PDR - Return
386-SS

GENERAL ELECTRIC

August 10, 1982

This letter is in response to your request for additional information concerning the certification drawings submitted for the G.E. Model 700 shipping container (Ref. 5). You noted that the certification drawings were not in complete agreement with the drawings now referenced in Certificate of Compliance No. 5942, Rev. 4. This is because the currently referenced drawings are engineering drawings intended for fabrication while the certification drawings more truly describe the existing dimensions of the casks as they were prepared from actual measurements. However, when fabrication tolerances are applied, the agreement between the two sets of drawings is generally good. General Electric is also updating the engineering drawings to describe the existing dimensions of the Model 700.

12904768

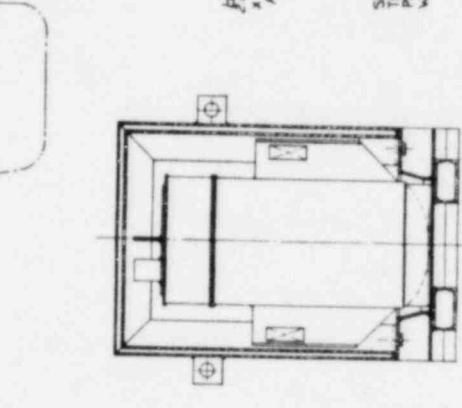
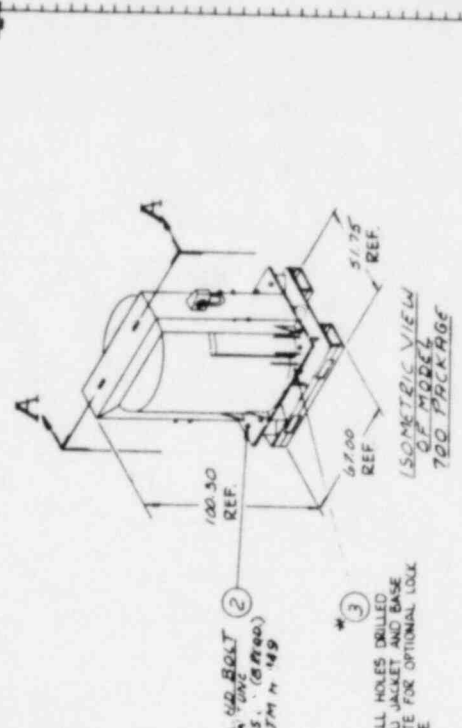
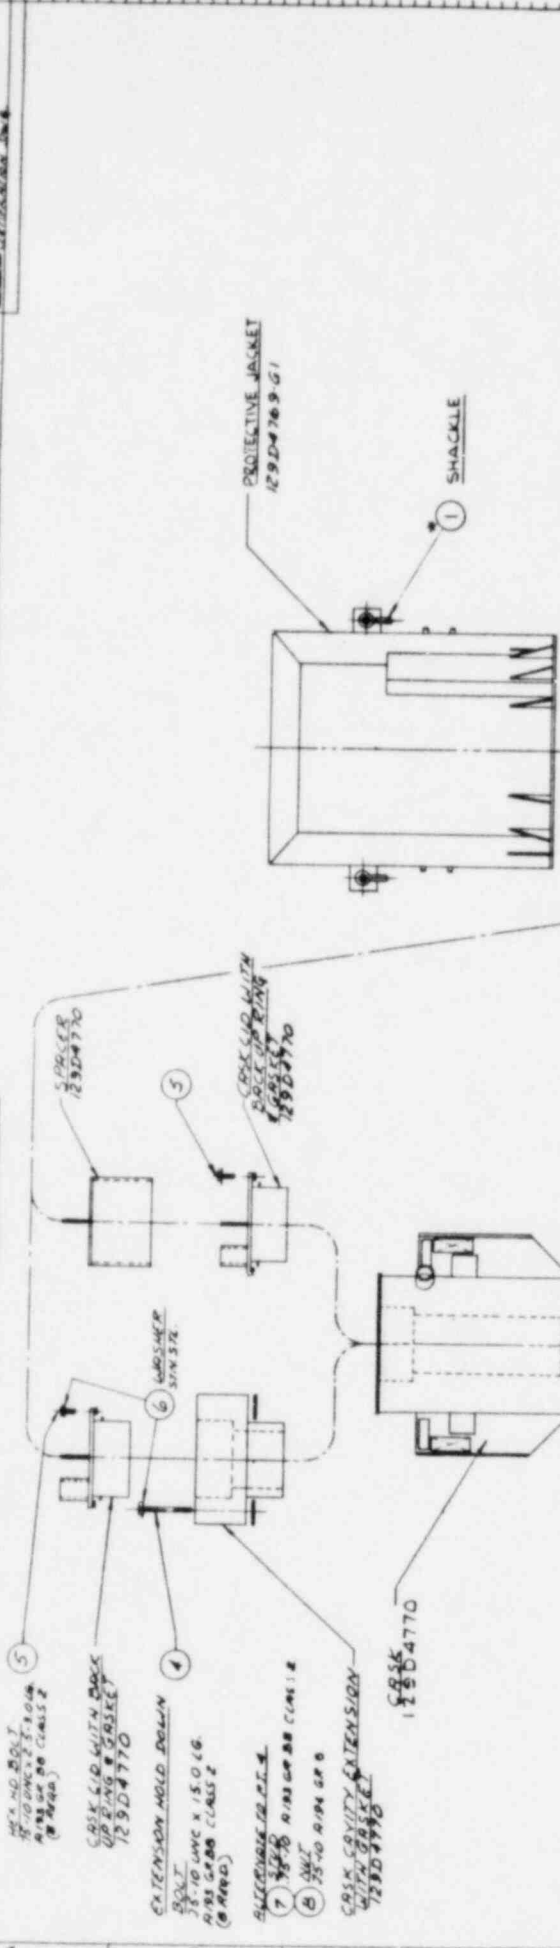
Item #2: The material specification called out in Certification Drawing 129D4768 (ASTM A-449) is the correct one. ASTM A-449 bolts are used on all large General Electric shielded shipping containers. There is no problem with safety as ASTM A-449 specification bolts were used on the Model 100 shipping container when it was subject to the thirty-foot drop test (this test was the basis for the design of closures and fire/crash shields of all the large G.E. shielded shipping containers).

12904769

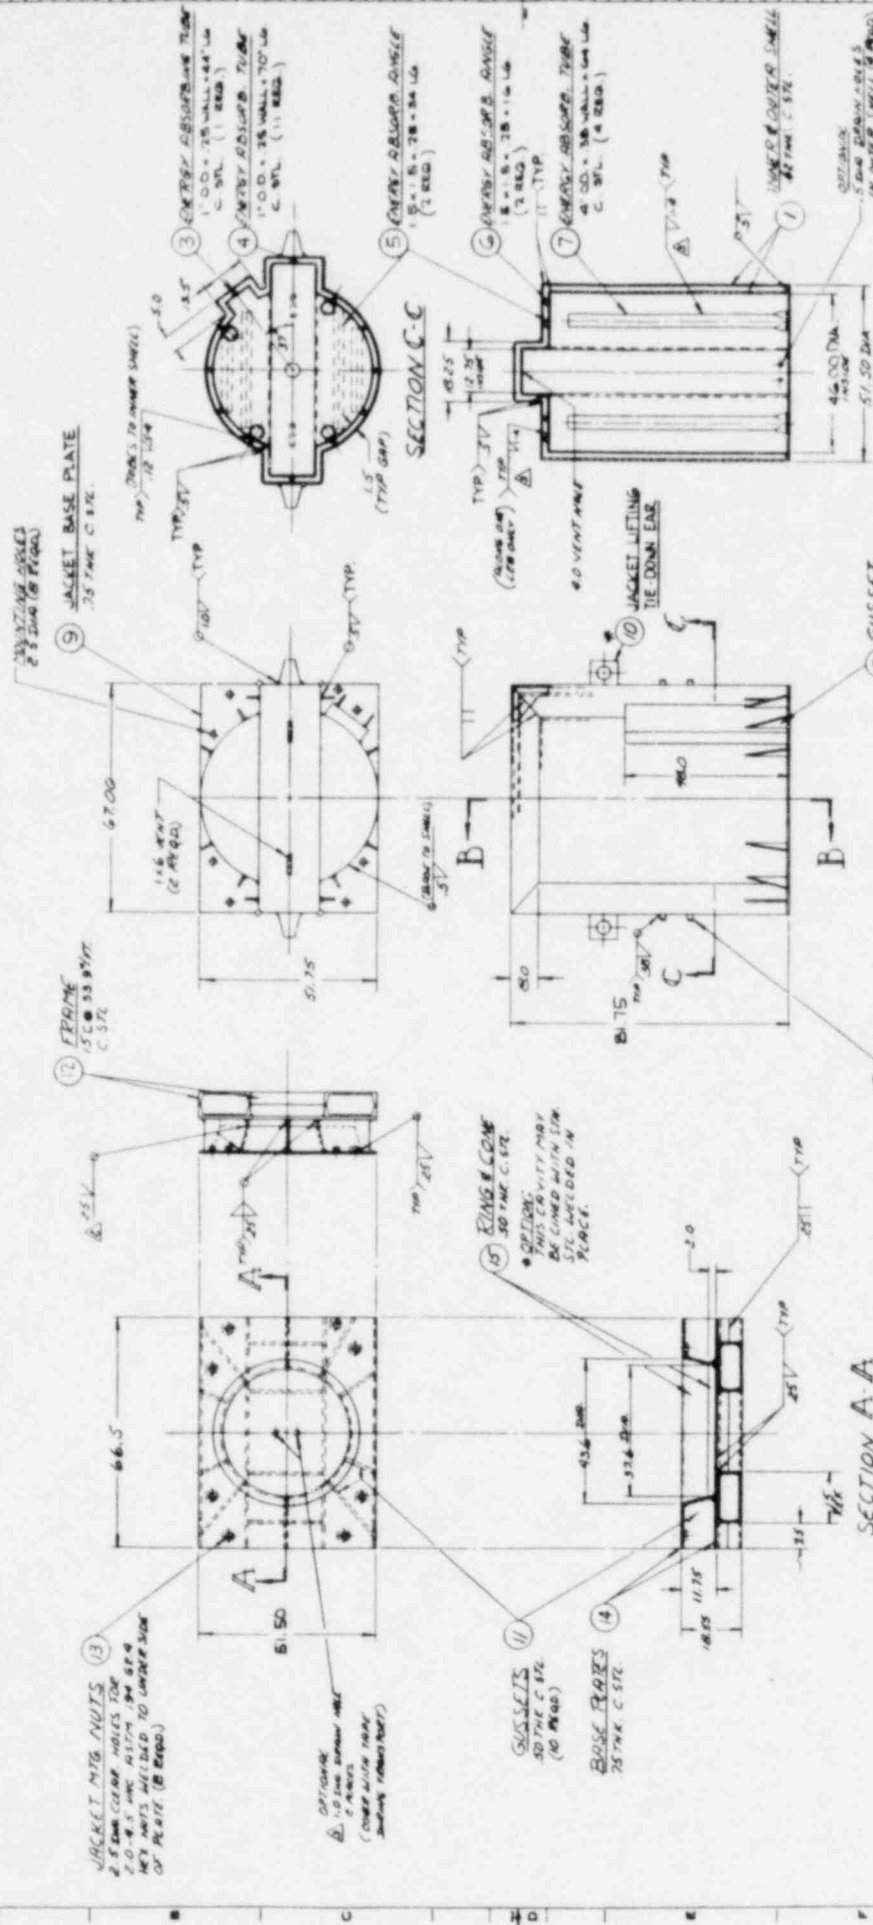
- (a) The fillet weld on the base detail (Zone B-5) has been deleted from Certification Drawing 129D4769.
- (b) The weld symbol (Zone B-5) which joins the ring and the gussets to the base plates has been modified on Certification Drawing 129D4769 to show the fillet weld on both sides.
- (c) The location and overall dimensions of the "elongated pocket" on the jacket shell have been added to Drawing 129D4769. A tolerance for the location was also added.

On Drawing No. 129D4769 two optional drain holes have been added to the base plates. These holes permit the draining of any water trapped during underwater loading/unloading operations.
